SUBJECT: Transmittal of Responses to AP1000 DSER Open Items

AP1000 Design Certification Review
Draft Safety Evaluation Report Open Item Non-Proprietary Responses

Draft Safety Evaluation Report Open Item Response

DCD Figure 6.3 (shows addition of recirculation screen cross connection)

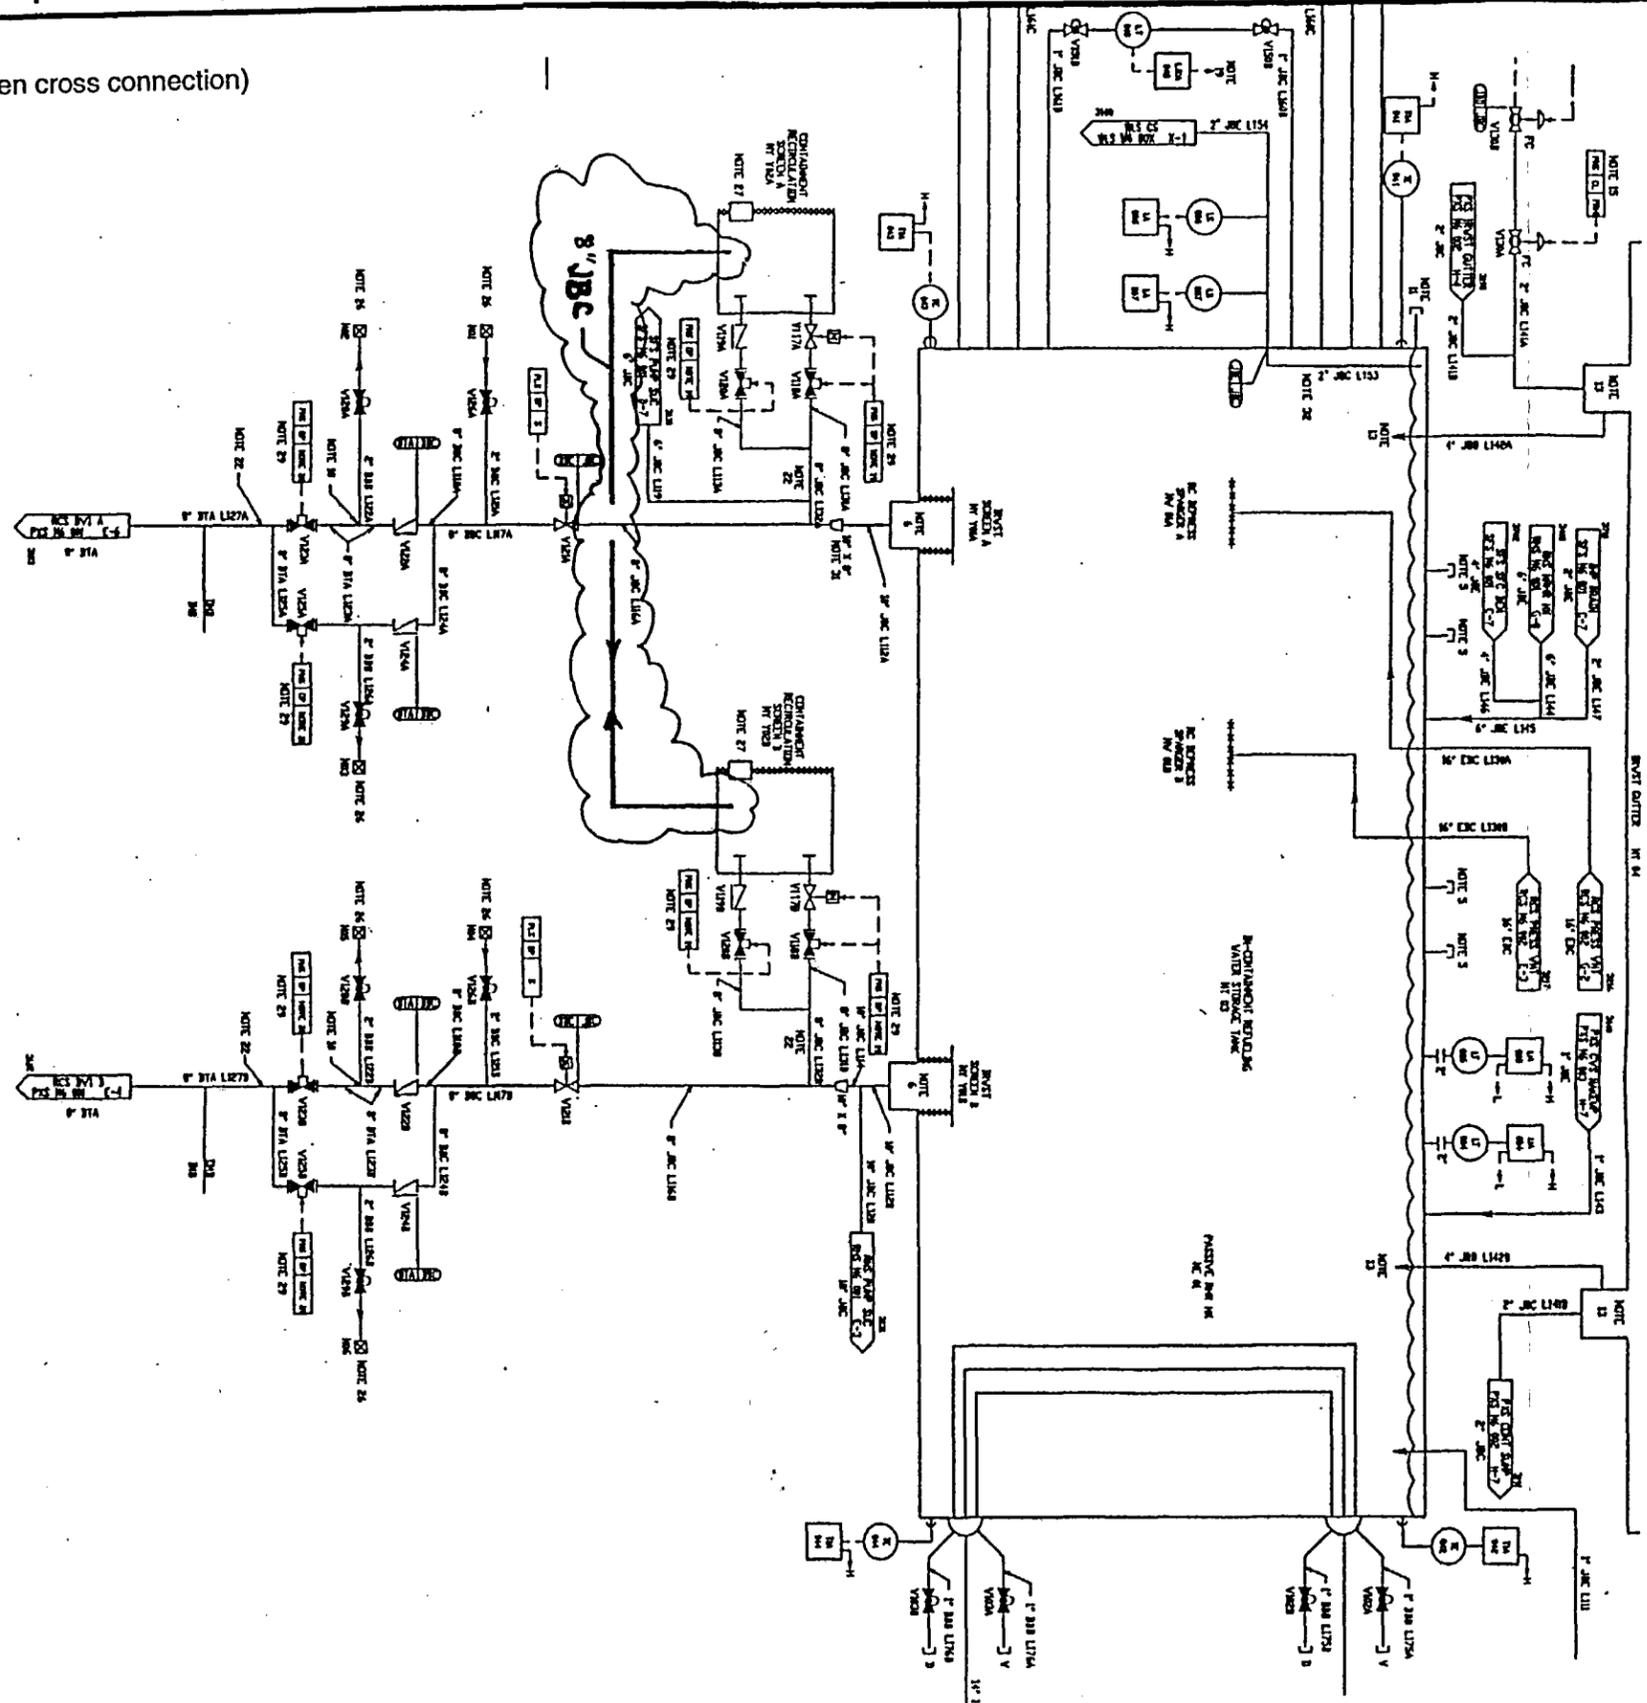
In addition, two design changes have been incorporated into the AP1000 to add additional margin to the ability of the recirculation screens to tolerate debris. Those changes include incorporation of additional screen area (through the use of a folded screen design) and the addition of a cross connection pipe between the two recirculation screens. The additional screen
